Newport Harbor High School Narrative Changes – Mechanical Addendum 1

January 26th, 2021

Attention: Mr. Lance Bidnick
Project: Newport Harbor High School
Newport Beach, California 92663
Subject: Narrative Changes – Mechanical Addendum 1

BAS NETWORK COMMUNICATION RISER DIAGRAM

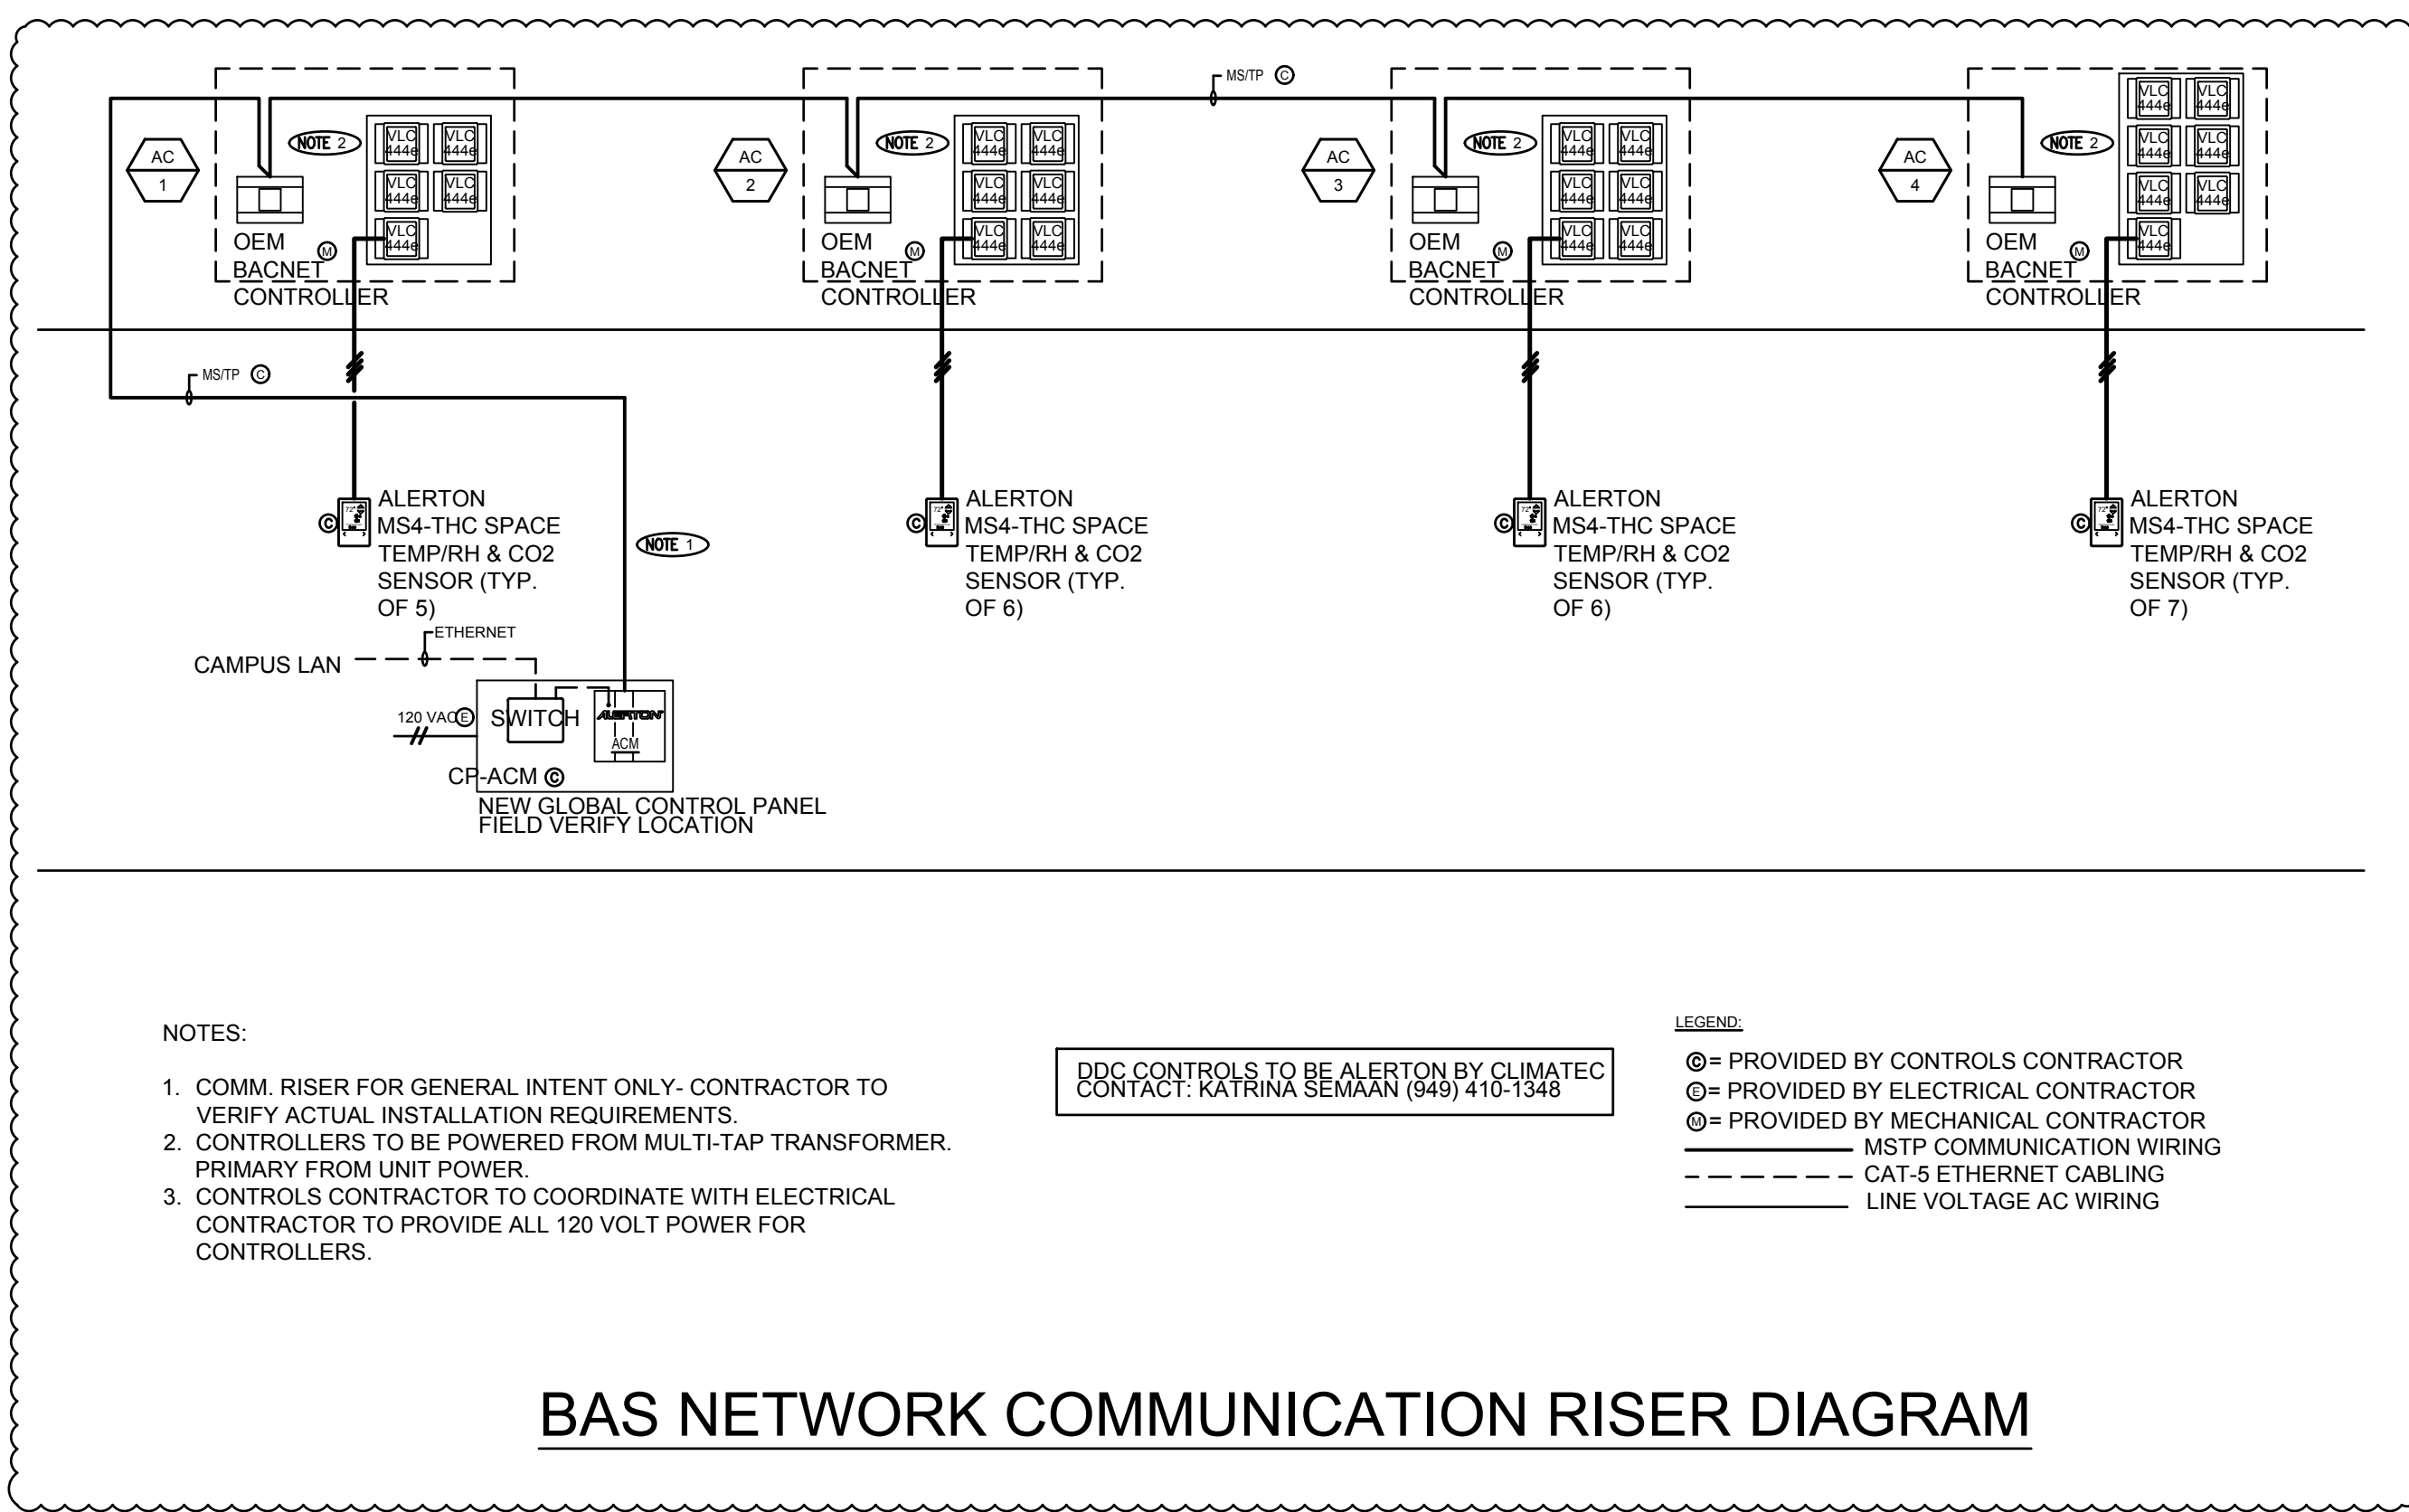
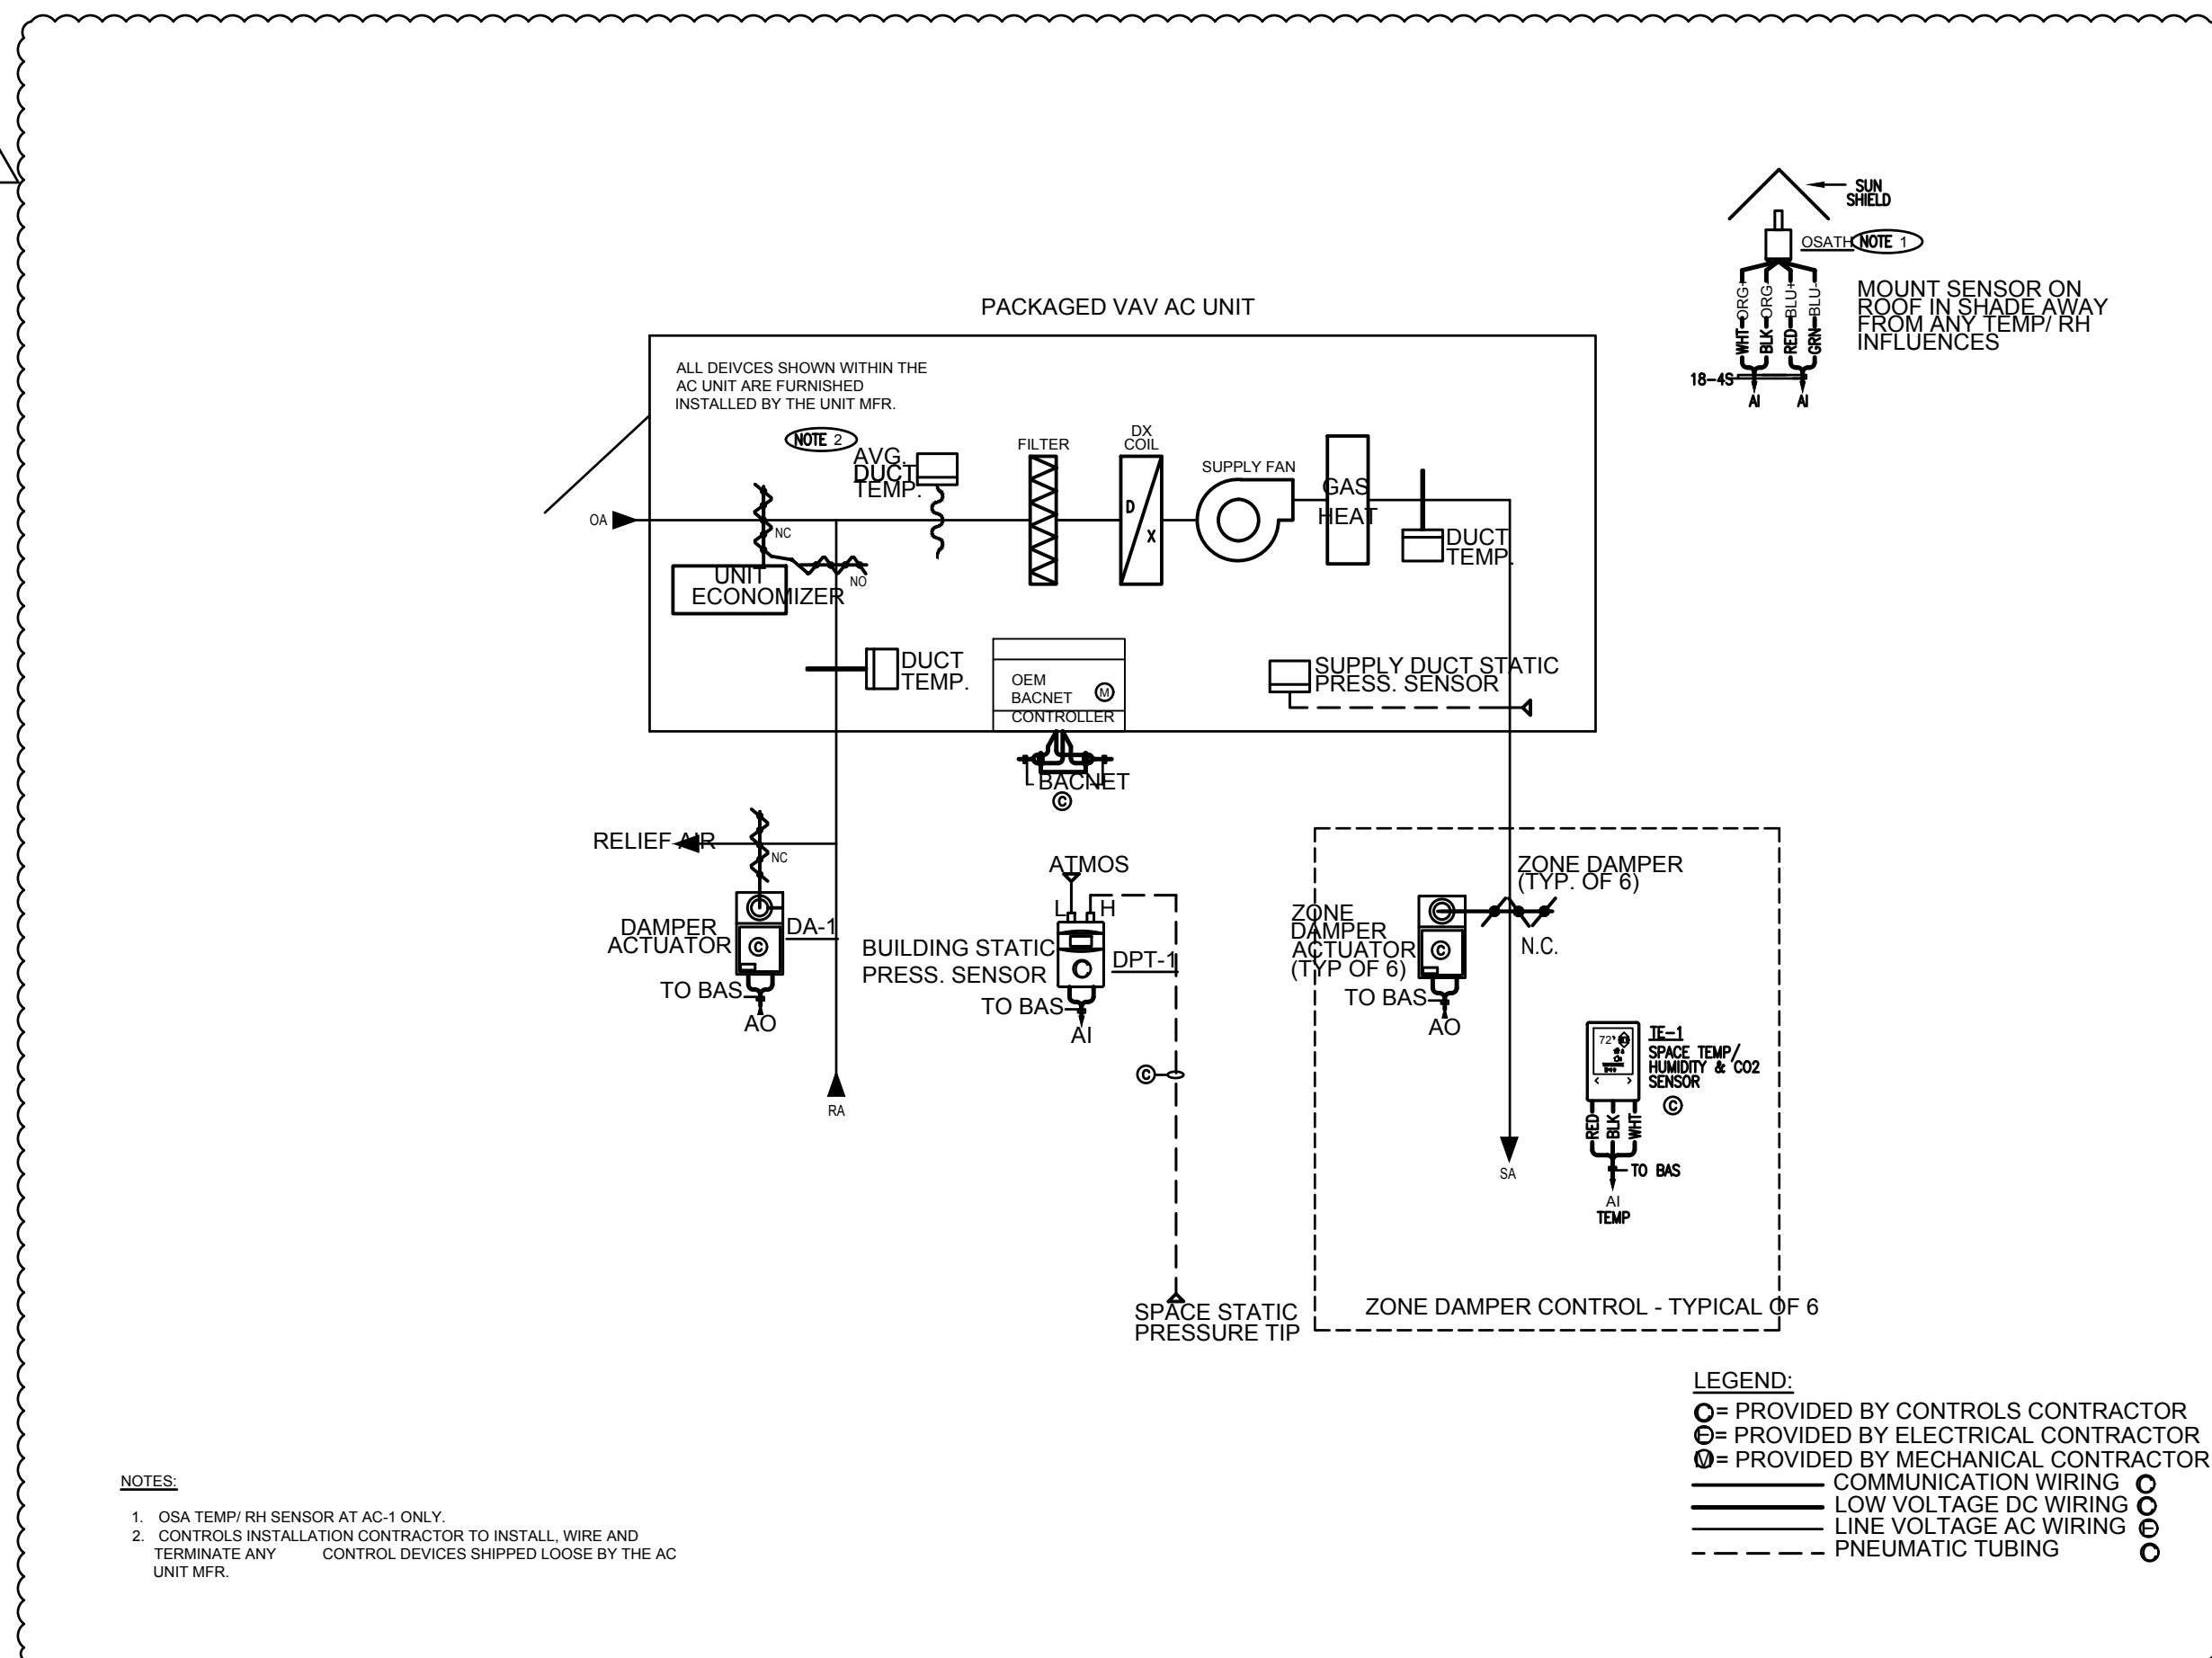
1. Revised communication riser diagram for units wiring directly from zone dampers to thermostats, number of zones for each unit corrected and instructions for powering controllers added to notes.
2. Revised Multizone and AC unit zone control diagram. Building static pressure sensor and return air damper actuator now incorporated.
